**CITY OF MARQUETTE
PLANNING AND ZONING
300 W. BARAGA AVENUE
MARQUETTE, MI 49855
(906) 225-0425
www.mqtcty.org**

TO: Planning Commission
FROM: Andrea Landers, Planning/Zoning Official
DATE: August 12, 2015
SUBJECT: 01-PUD-08-15 – Request for PUD Criteria Qualification for Duke LifePoint – 850 W. Baraga Ave. (PIN: 0130100, 0240013, 0514071, and 0514072)

STAFF FILE REVIEW/ANALYSIS

**RE: Preliminary PUD Plan Submittal
UP Health – Marquette Replacement Hospital**

Figure 1: Location of Transition from 8" to 12" Watermain

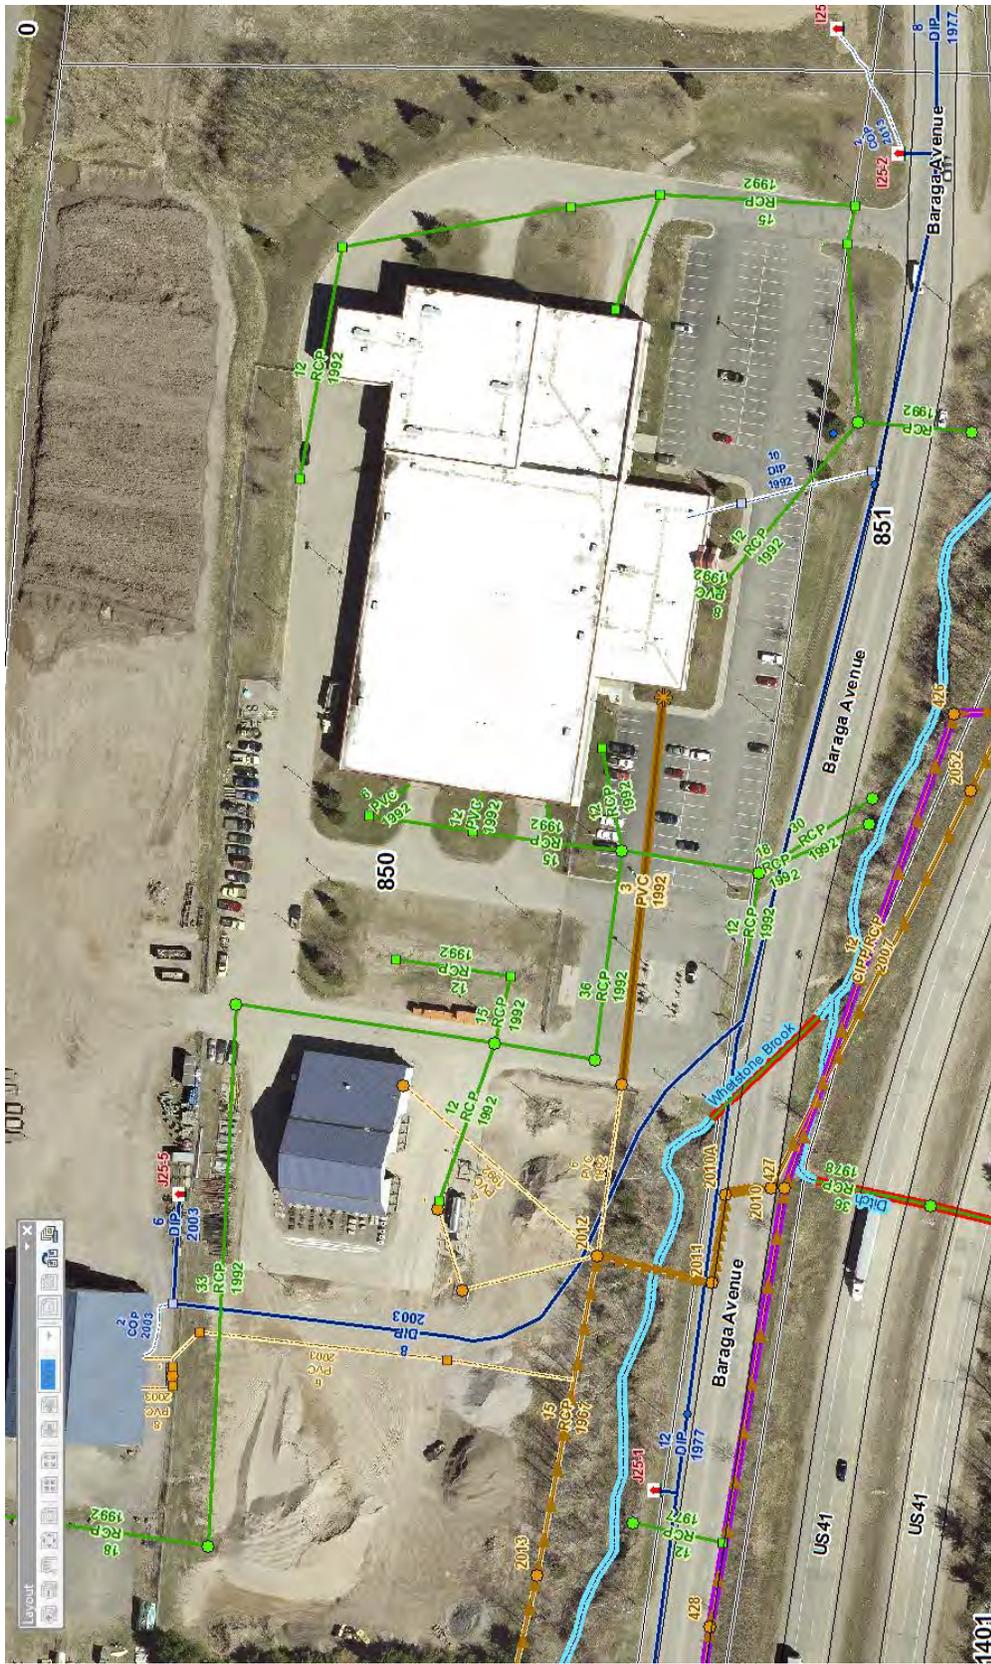
6. Please remove or reduce the font size of the bearings and distances where oversized.
7. Please label all property line bearings and distances.
8. Please revise that portion of the existing 8” watermain that is shown as 12”. Watermain information is provided on Figure 1 provided at the end of this review and shows where the 8” watermain transitions to the 12” watermain.

7. Please label all property line bearings and distances.
LEA Response: All property line bearings and distances will be added prior to resubmittal.
8. Please revise that portion of the existing 8" watermain that is shown as 12". Watermain information is provided on Figure 1 provided at the end of this review and shows where the 8" watermain transitions to the 12" watermain.
LEA Response: The existing watermain sizes have been corrected per the provided Figure 1.

C5.0
 OVERALL LAYOUT PLAN

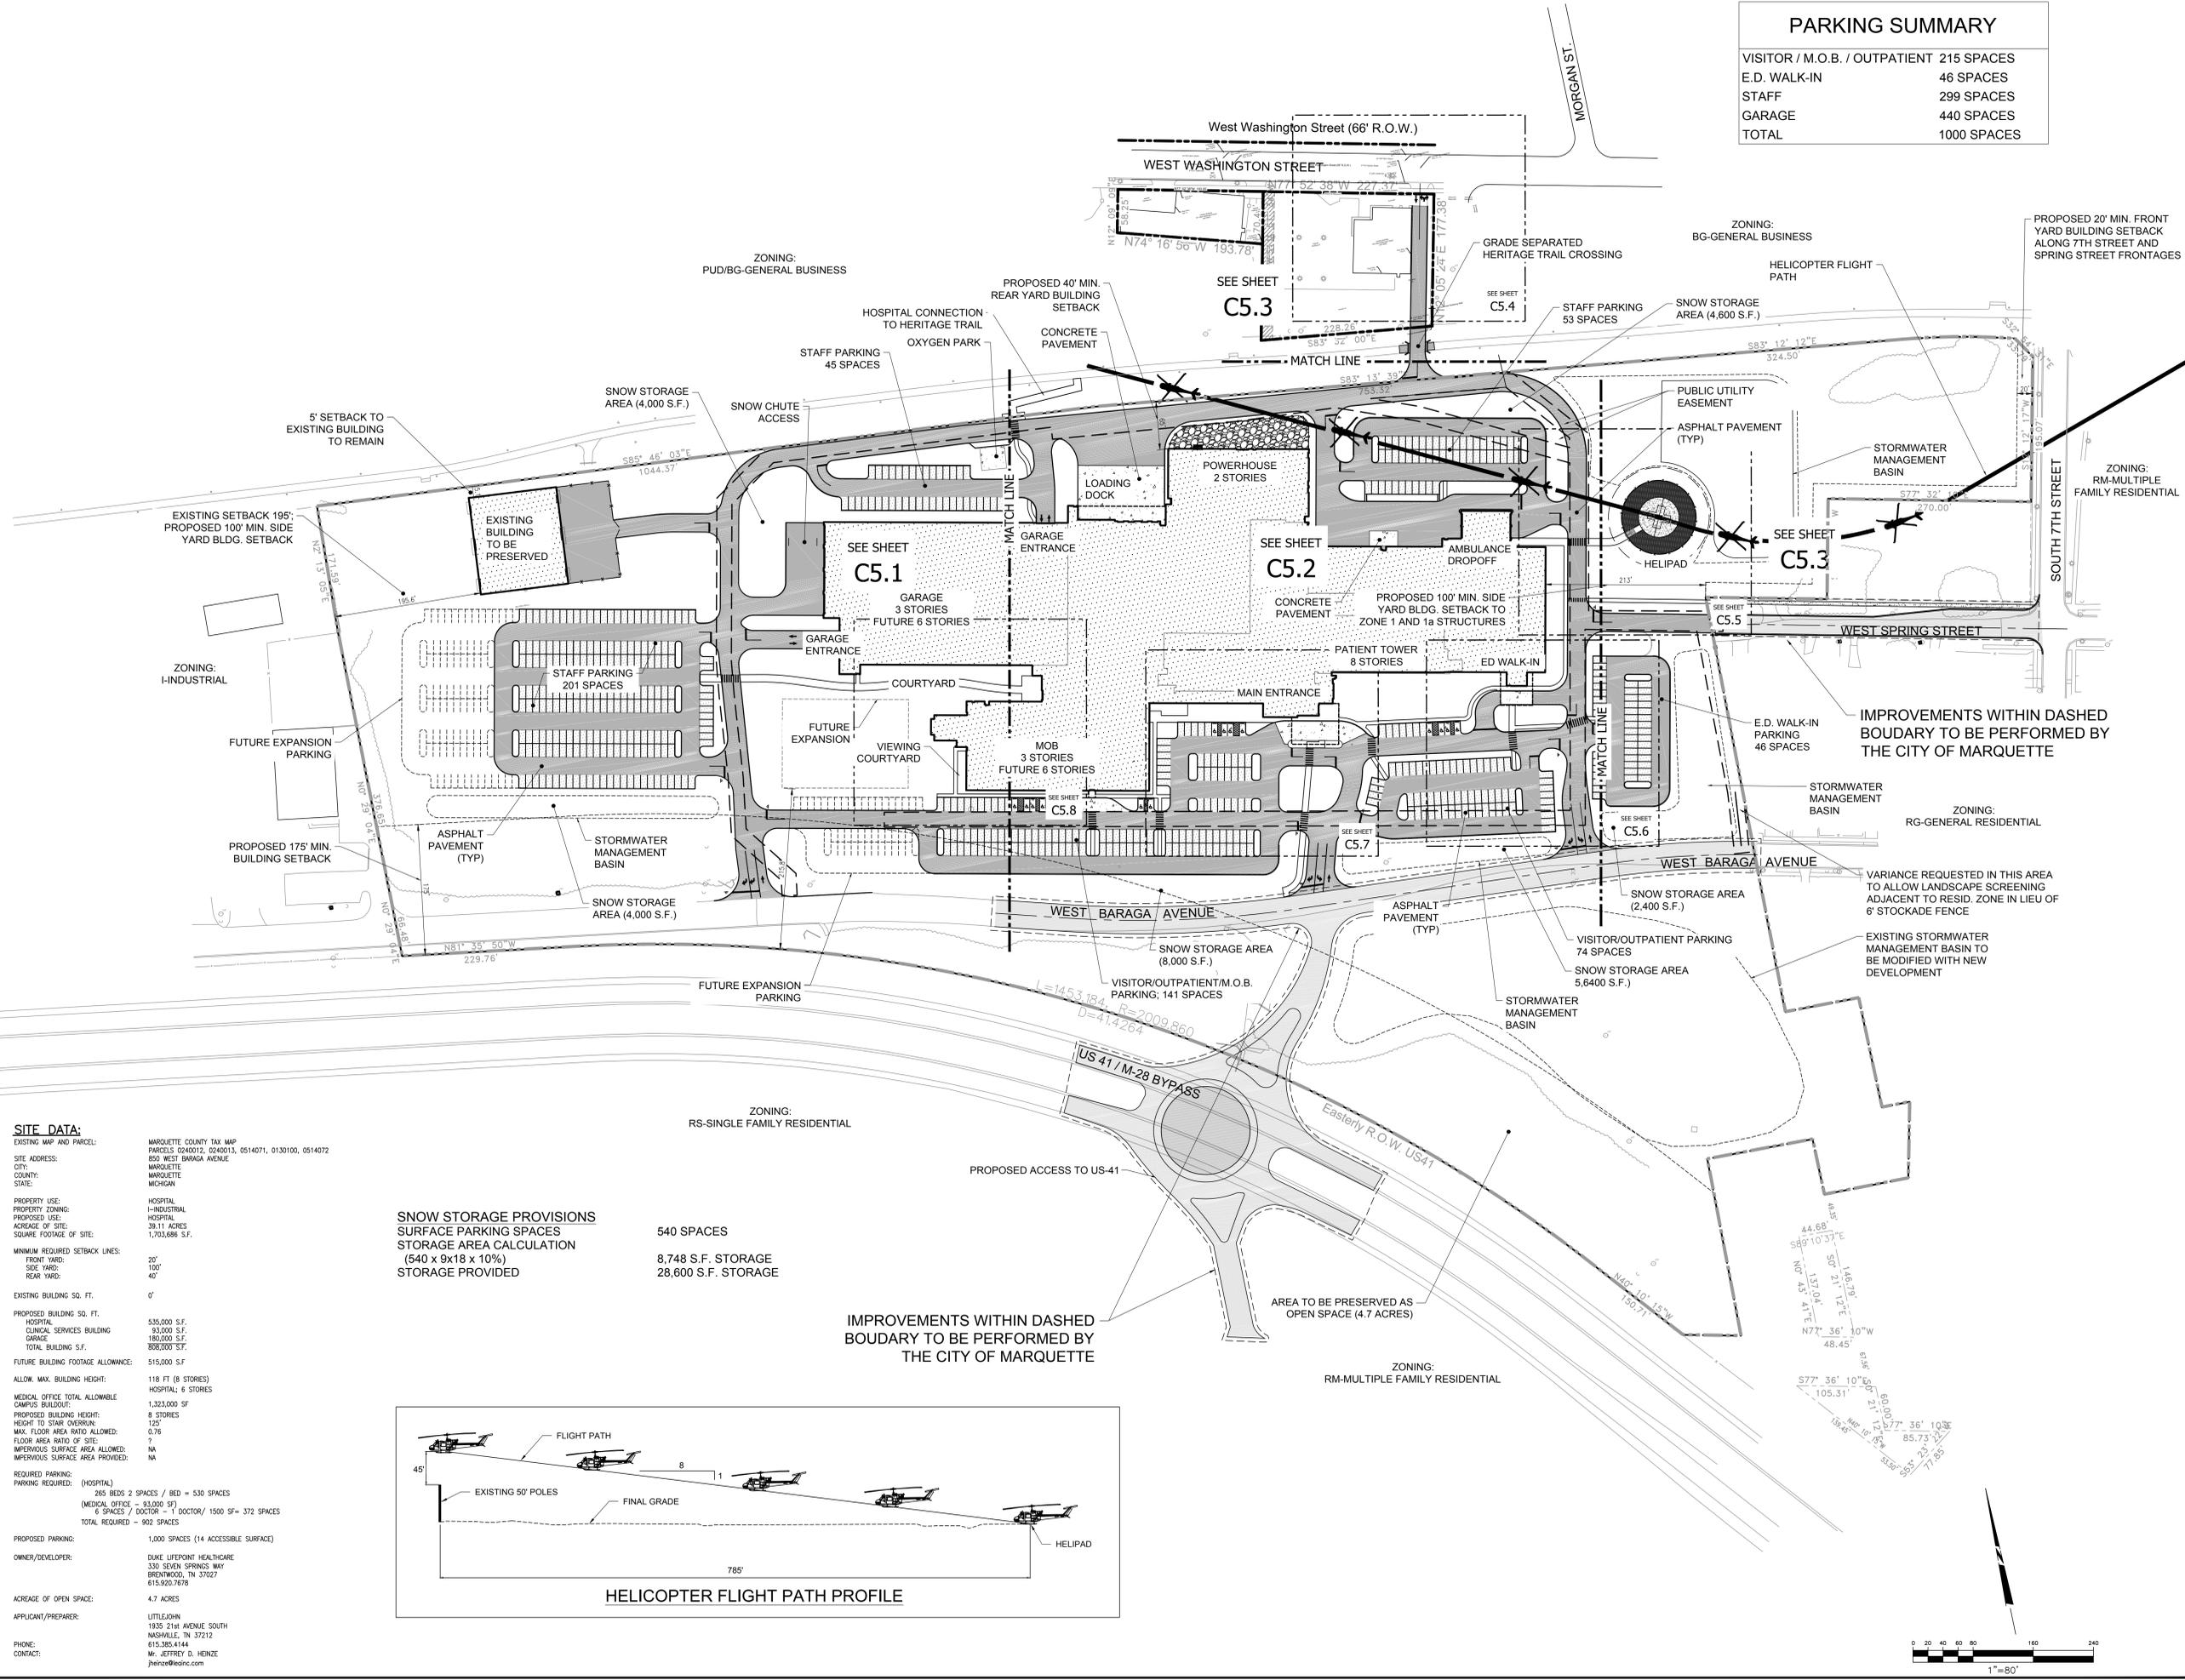
4. Missing the flight path for the helicopters.
LEA Response: The helicopter flight path has been shown on the Overall Site Layout Plan, sht. C5.0.

Sheet C5.0 - The helicopter glide path crosses the city parcel located on the NW corner of Spring st. and 7th st. This is the potential location of a future fire station. As such, there may be a communications and/or hose tower placed on this parcel. The helicopter glide path will have to be moved farther north so as not to cross this parcel.

7. Sheet C5.0-The helicopter glide path crosses the City parcel located on the NW corner of Spring St. and 7th St. This is the potential location of a future fire station. As such, there may be a communications and/or hose tower placed on this parcel. The helicopter glide path will have to be moved farther north so as not to cross this parcel.

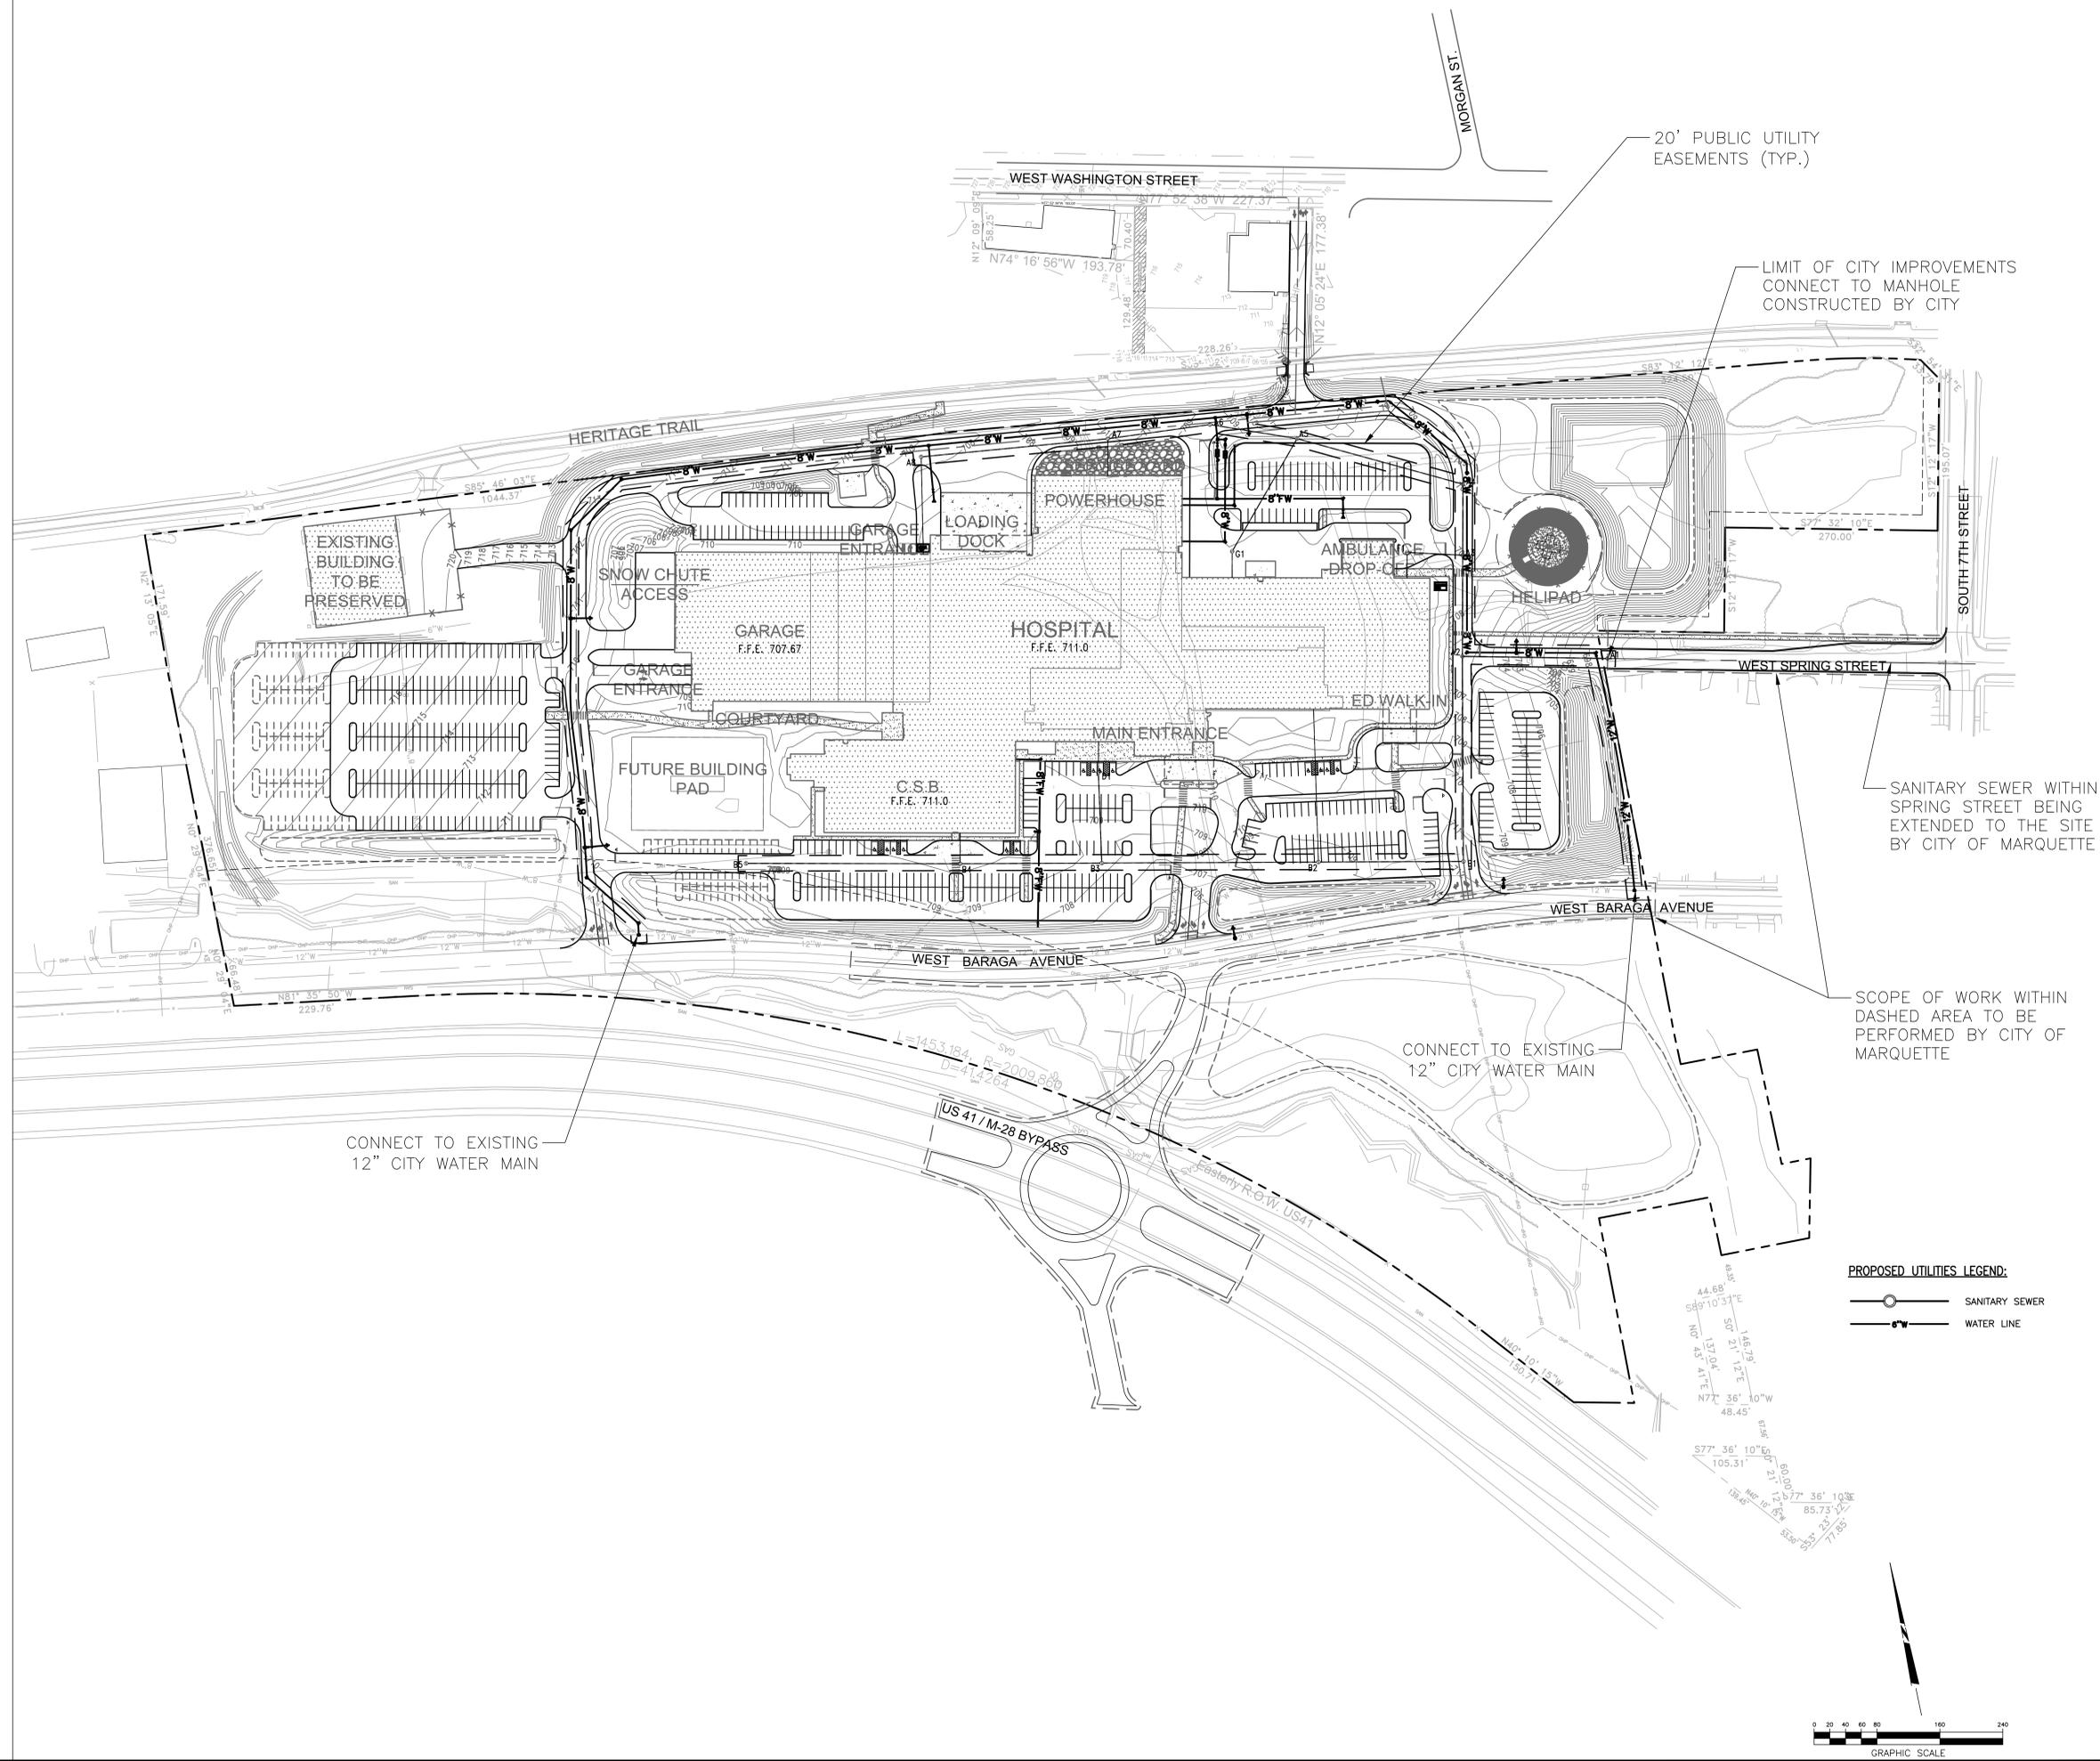
9. Please show all the sanitary sewers on the west side of the property as shown on Figure 2 provided at the end of this review. Please include the sanitary sewer from the City storage building that is to remain and the three sanitary laterals discharging to manhole 2012.

10. Please show the existing storm sewers as shown on Figure 2 provided at the end of this review, including
 - a. The storm sewer located on the west side of the property. This storm sewer serves the Liberty Way property and will need to be accommodated.

11. Please identify material and diameter of all existing utilities. Utility material and diameter information is provided on Figure 2 provided at the end of this review.
12. Please show and label the existing check valve vault on the east side of the property and west of 620 Baraga Avenue. This check valve is shown on Figure 3 provided at the end of this review.

9. Please show all the sanitary sewers on the west side of the property as shown on Figure 2 provided at the end of this review. Please include the sanitary sewer from the City storage building that is to remain and the three sanitary laterals discharging to manhole 2012.
LEA Response: The sanitary sewers shown in Figure 2 have been added to the plans. The three laterals currently discharging into manhole 2012 will be removed.

10. Please show the existing storm sewers as shown on Figure 2 provided at the end of this review, including
 - a. The storm sewer located on the west side of the property. This storm sewer serves the Liberty Way property and will need to be accommodated.
LEA Response: The existing storm sewer has been added to the plans. The portions that will be removed have been noted on the Demolition Plan, sheet C4.0. The new storm line added to accommodate the off-site drainage is shown on the Site Grading Plan, sheet C6.0.

11. Please identify material and diameter of all existing utilities. Utility material and diameter information is provided on Figure 2 provided at the end of this review.
LEA Response: Material and diameter of all existing utilities will be added to the plans per Figure 2 prior to resubmittal.
